NOTES ON CHANGES TO THE LAYOUT ORIGINALLY SUBMITTED FOR THE RESERVED MATTERS APPLICATION

CLIENT	STUART & MARCIA LYONS
PROJECT	WINDROOS, LITTLEHAMPTON
TITLE	PROPOSED SITE PLAN - RESPONSE TO RESERVED MATTERS COMMENTS

NUMBER	13121 - SK01 A
--------	----------------

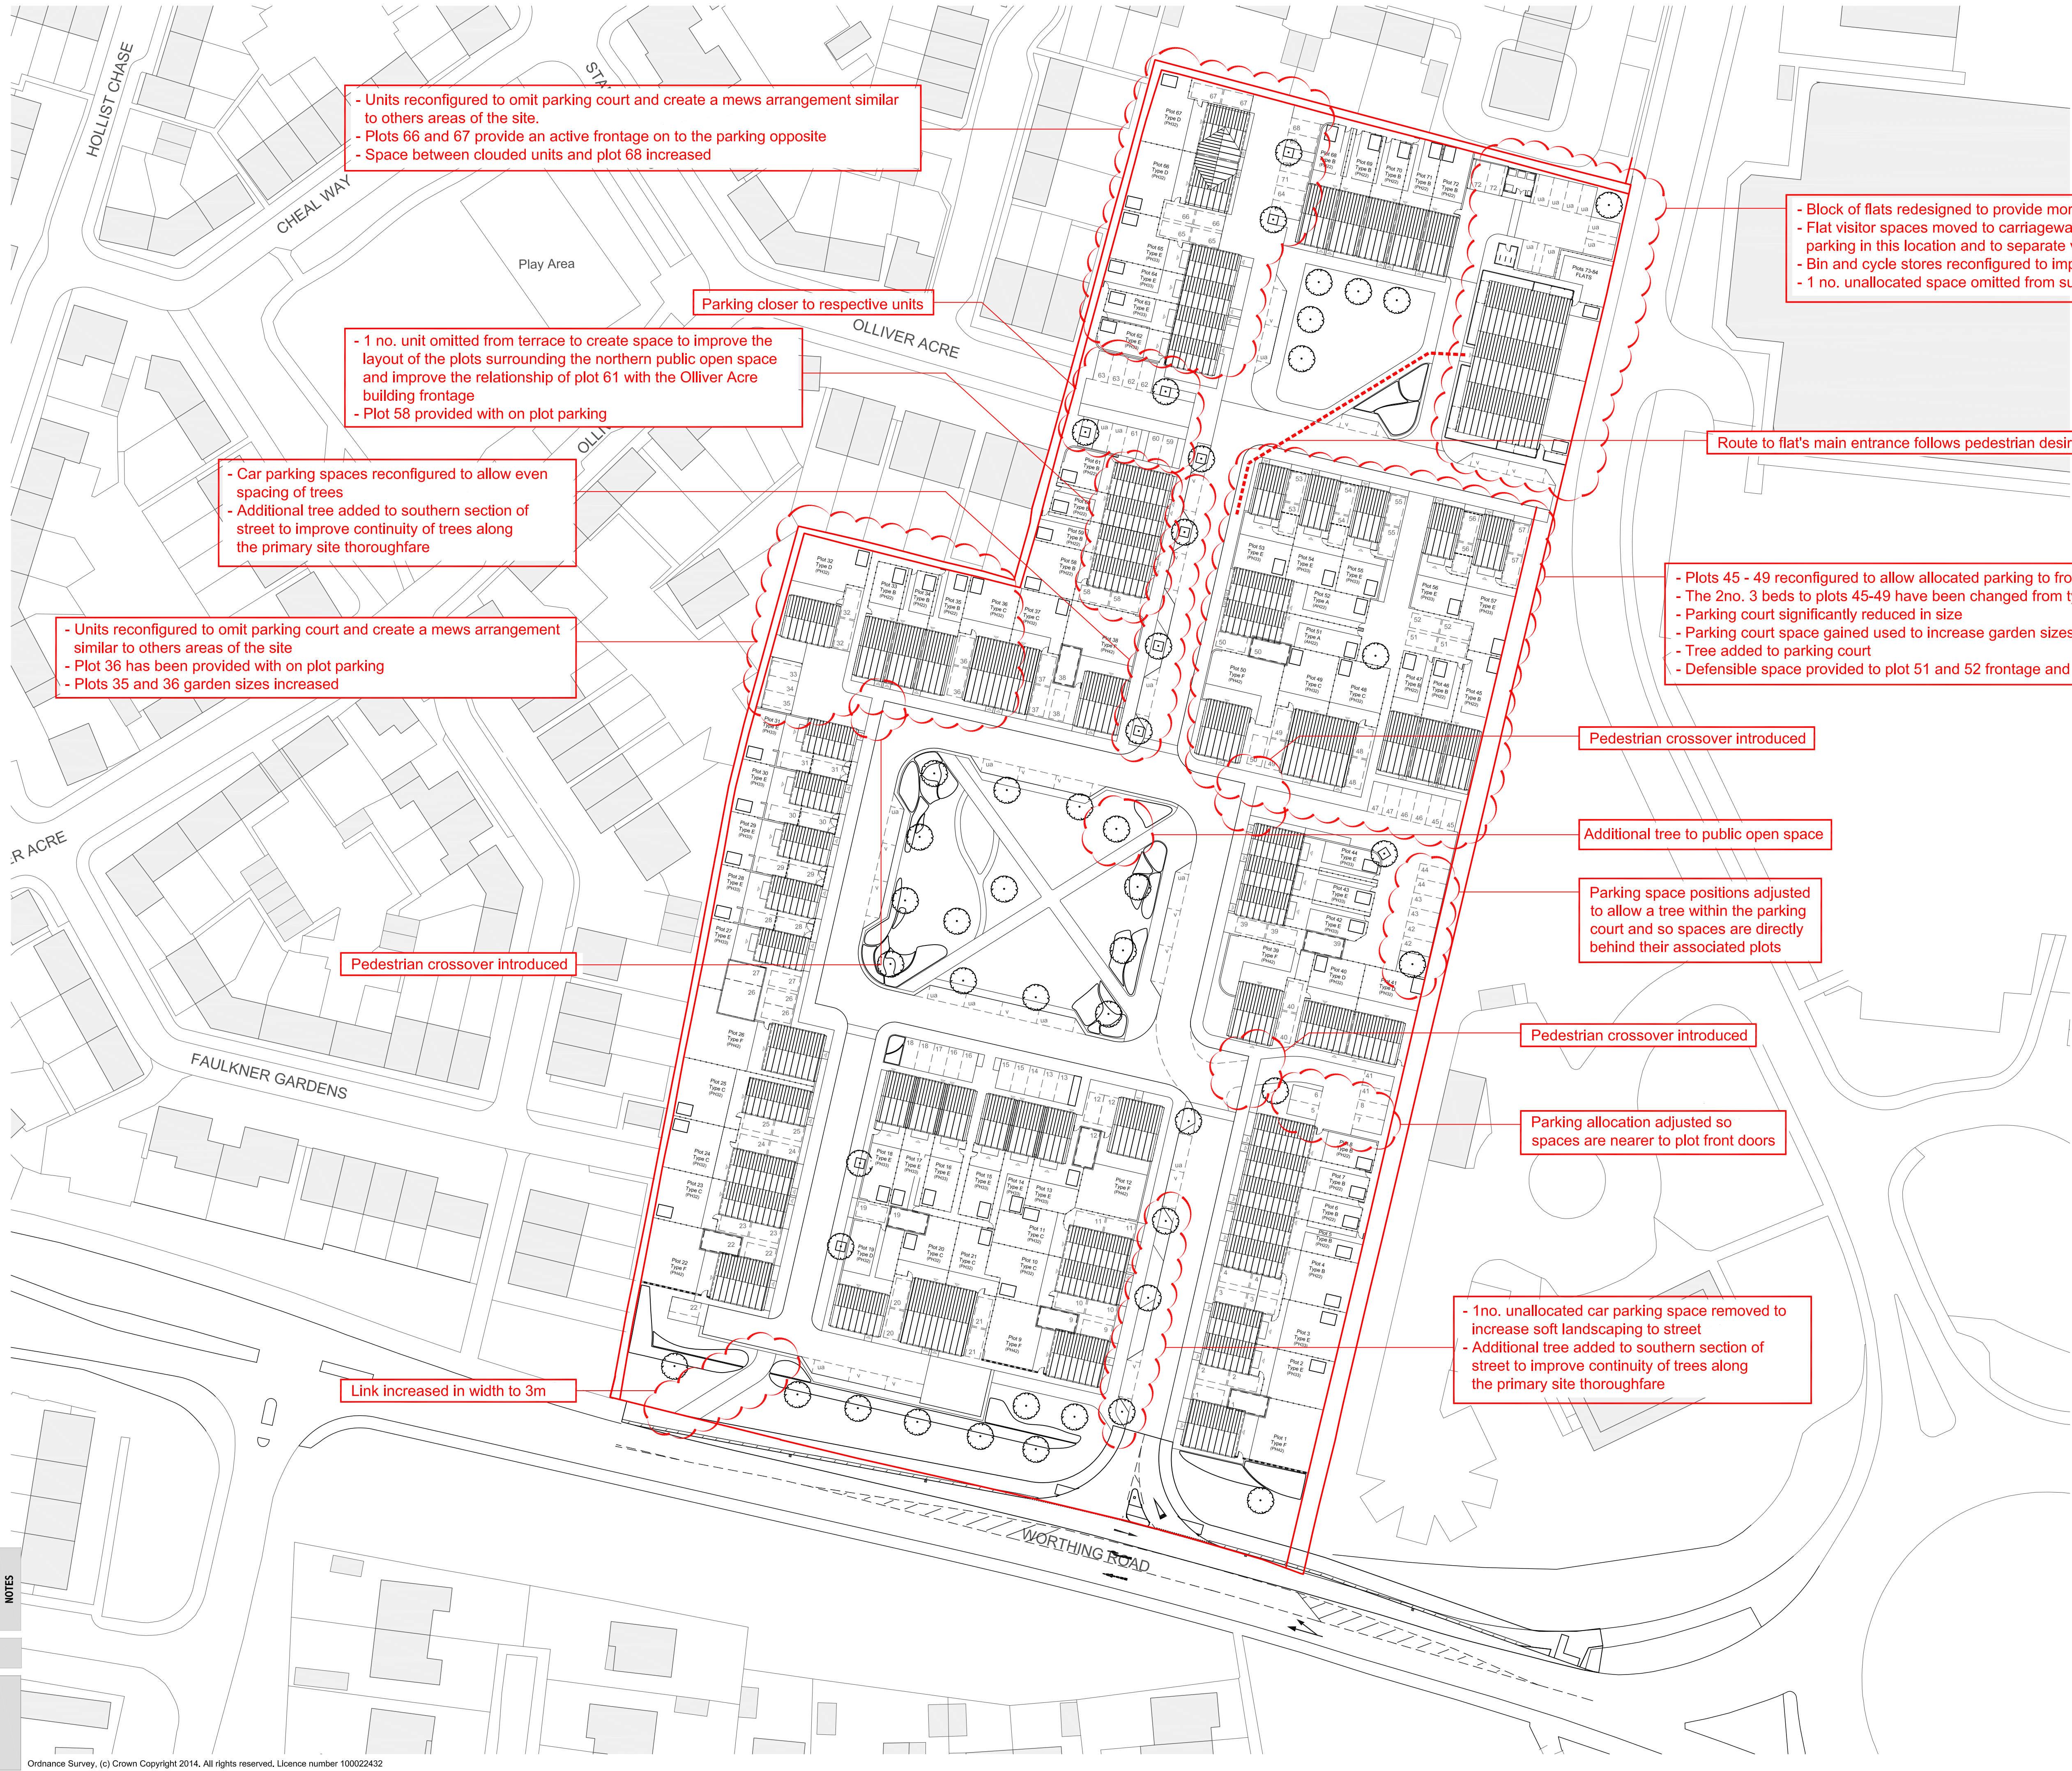
- Units reconfigured to omit parking court and create a mews arrangement similar to others areas of the site.
- Plots 66 and 67 provide an active frontage on to the parking opposite
- Space between clouded units and plot 68 increased

Parking closer to respective units

- 1 no. unit omitted from terrace to create space to improve the layout of the plots surrounding the northern public open space and improve the relationship of plot 61 with the Olliver Acre building frontage
- Plot 58 provided with on plot parking

- Car parking spaces reconfigured to allow even spacing of trees
- Additional tree added to southern section of street to improve continuity of trees along the primary site thoroughfare

- Units reconfigured to omit parking court and create a mews arrangement similar to others areas of the site
- Plot 36 has been provided with on plot parking
- Plots 35 and 36 garden sizes increased

Pedestrian crossover introduced

- Block of flats redesigned to provide more space between the building and site boundary.
- Flat visitor spaces moved to carriageway on south side of building formalising the parking in this location and to separate visitor and resident parking.
- Bin and cycle stores reconfigured to improve resident amenity and green space layout.
- 1 no. unallocated space omitted from submitted plan

Route to flat's main entrance follows pedestrian desire line

- Plots 45 - 49 reconfigured to allow allocated parking to frontage or on plot parking.
- The 2no. 3 beds to plots 45-49 have been changed from type D to type C
- Parking court significantly reduced in size
- Parking court space gained used to increase garden sizes / accord with standards
- Tree added to parking court
- Defensible space provided to plot 51 and 52 frontage and plot 53 west (side) elevation

Pedestrian crossover introduced

Additional tree to public open space

Parking space positions adjusted to allow a tree within the parking court and so spaces are directly behind their associated plots

Pedestrian crossover introduced

Parking allocation adjusted so spaces are nearer to plot front doors

- 1no. unallocated car parking space removed to increase soft landscaping to street
- Additional tree added to southern section of street to improve continuity of trees along the primary site thoroughfare

Link increased in width to 3m
